Statement of Response to ABP's Opinion

**Lands at Docklands Innovation Park ,
128-130 East Wall Road, Dublin 3.**

John Spain Associates

February 2020

Figure 2: Existing Land use mix within the Z14 area-(residential use indicated in yellow hatching and commercial use indicated in red hatching) with subject site indicated

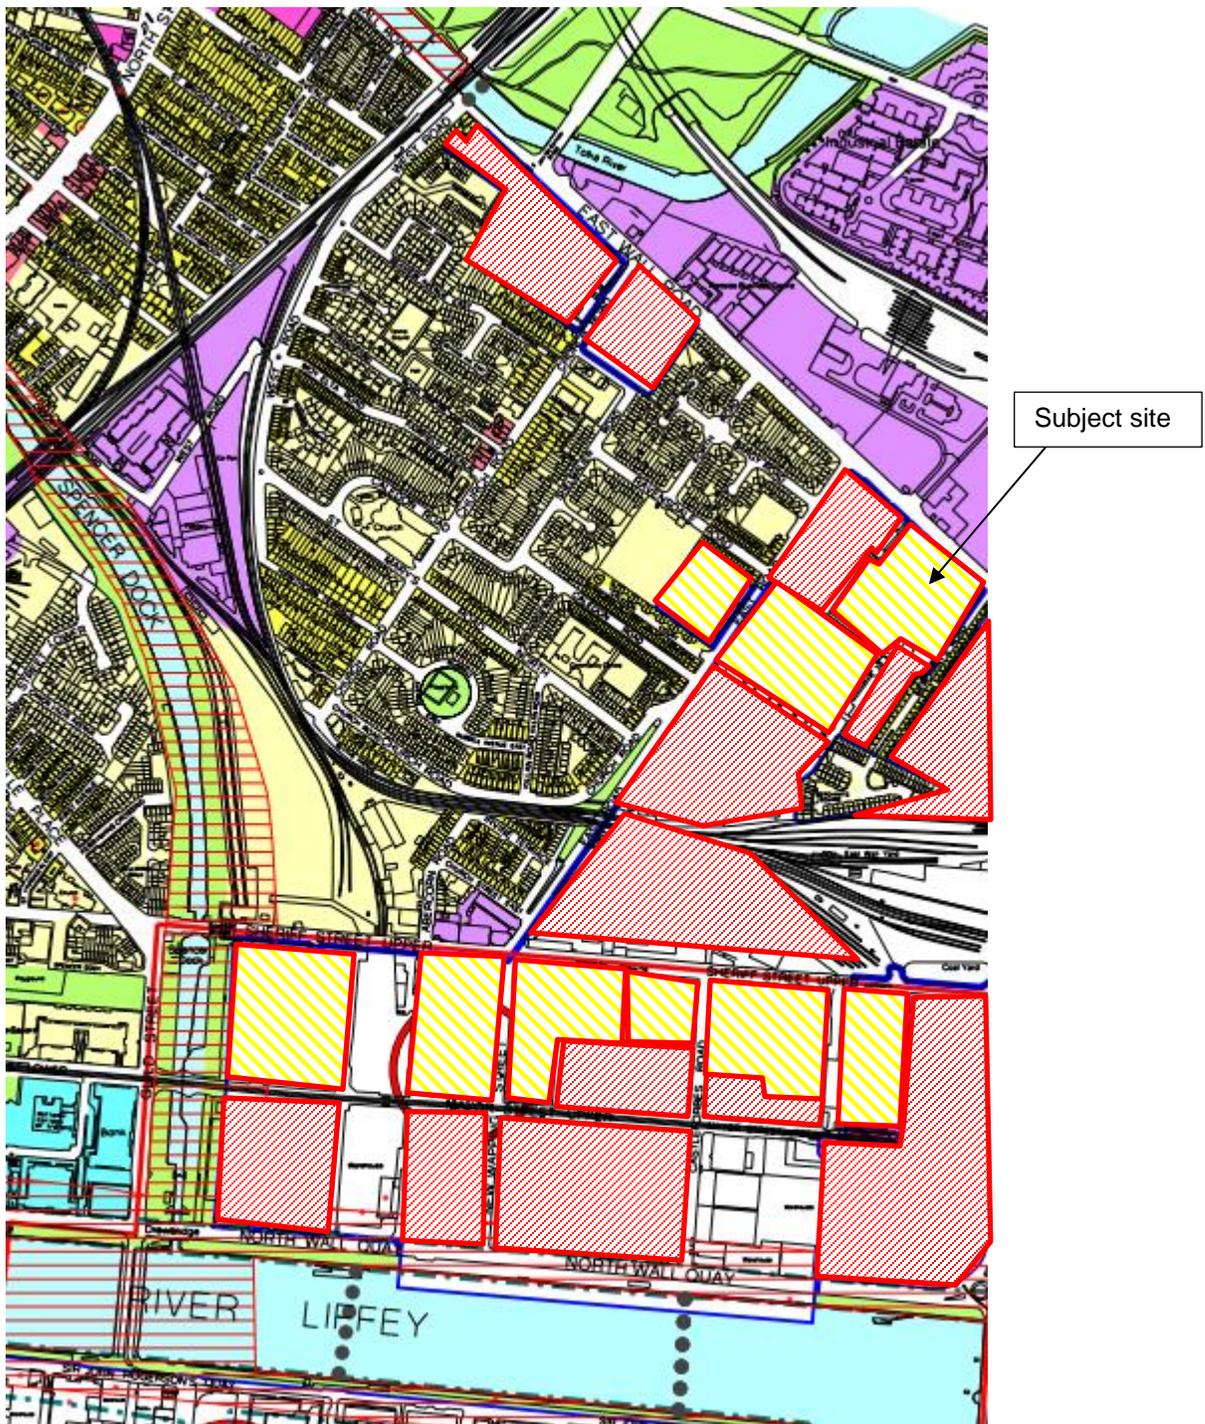
Item No. 3- A study or report describing the existing mix and composition of land uses on and in the vicinity of the site in the context of the current Z14 zoning objective for the area.

- 2.15 Having regard to the entire area zoned Z14 in the area, the majority of the Z14 lands surrounding the subject site including the SDZ area are in commercial use (as indicated in red hatching) with only 2 no. sites in residential use outside the SDZ area (as indicated in yellow hatching) as indicated in the zoning map below. The level of commercial use in the area therefore far exceeds the intention of the Z14 zoning which seeks to provide a mix of uses.

- 2.18 The Z14 zoned lands also include the North Lotts and Grand Canal Dock SDZ area which has a set land use mix for residential and commercial uses. The SDZ area however, has not delivered on the residential proportion of the land use mix. The SDZ area is predominantly office use with only limited residential use delivered to date. The Z14 zoning in the Docklands has therefore been very successful in employment creation but has exacerbated shortage of residential in the area. There is an urgent need for significant residential development to support this job creation and inward investment within the overall Z14 zoned lands.
